4318 STONE WAY N MIXED-USE BUILDING

4318 Stone Way N Mixed-Use Building
Project No. 3038261-LU

Design Recommendation
06/26/2023

8.0 ITEMIZED RESPONSE TO EDG

EDG STREETScape DESIGN
NTS

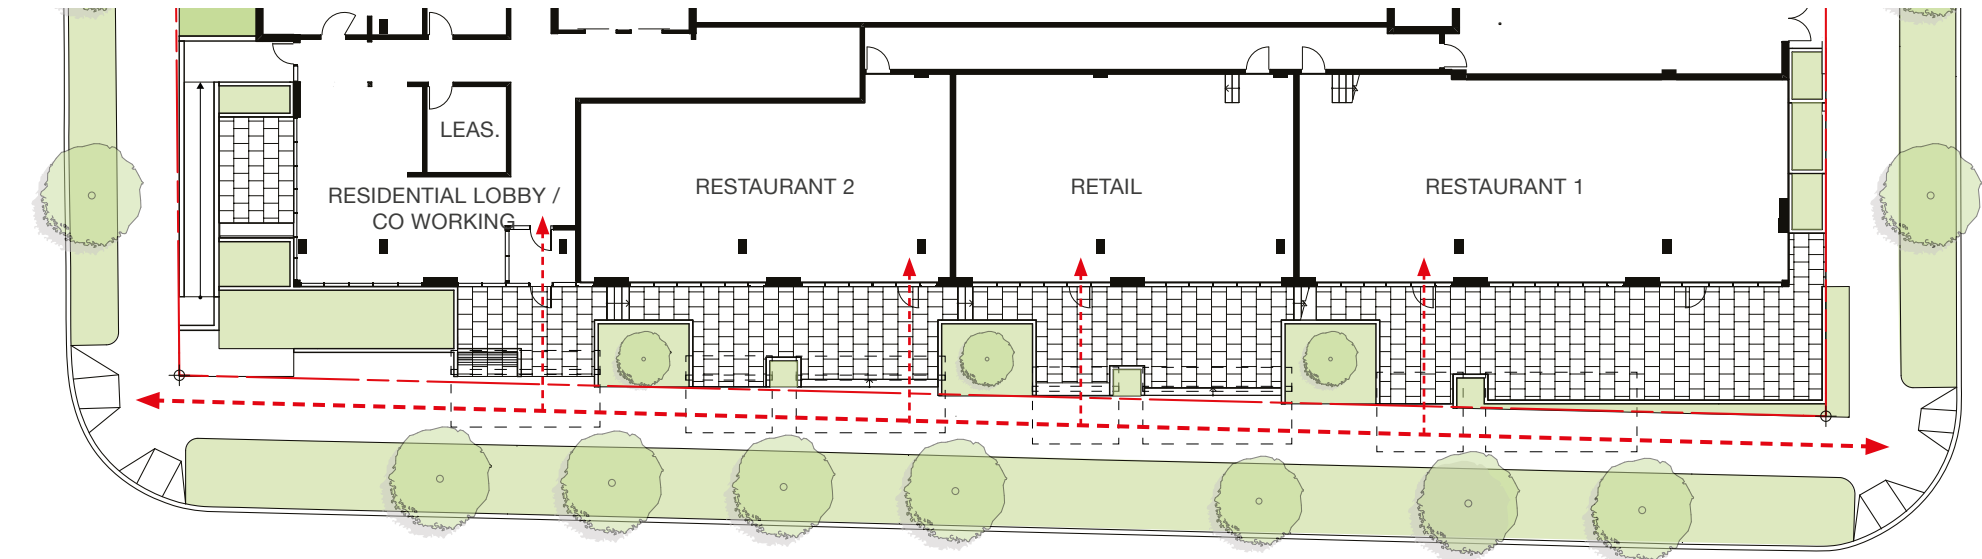
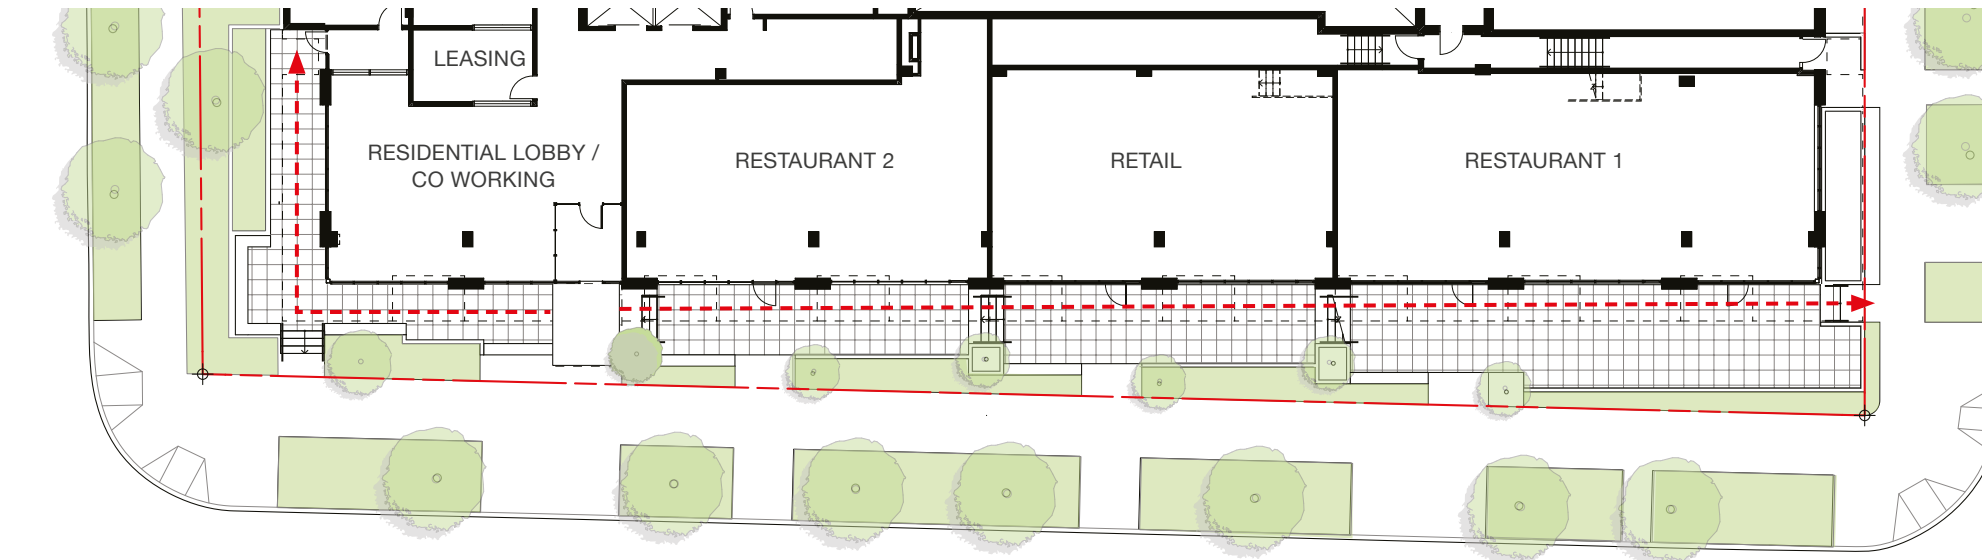
The Board questioned whether the exterior stair connections between the retail spaces was necessary and encouraged further exploration of a stronger planting frame that is designed clarify and guide users to the different retail entrances. In addition, the Board said that the use of larger shrubs and trees where feasible would also help in creating outdoor spaces or nodes in front of retail establishments. (CS2-I-ii, CS2-II, PL1-C, PL2-C, PL2-I-ii).

The proposed streetscape design is an evolution of the concept proposed at Early Design Guidance informed by the Board comments. At Early Design Guidance, the terraces were connected to adjacent terraces with site stairs and accessed from the sidewalk via an at-grade walkway and site stairs. The resultant space did not provide good opportunities for retail or restaurant uses and their permeability did not help wayfinding.

The proposed streetscape design removes the stairs connecting the sidewalk to each of the terraces. This focuses the point of entry and begins to zone the space of each terrace. The stairs connecting between terraces are maintained, providing a covered walkway during inclement weather when the terraces are likely to be less active. Using the building overhang to provide overhead weather protection allows the removal of the series of canopies shown at Early Design Guidance and thereby allows more expansive landscaping.
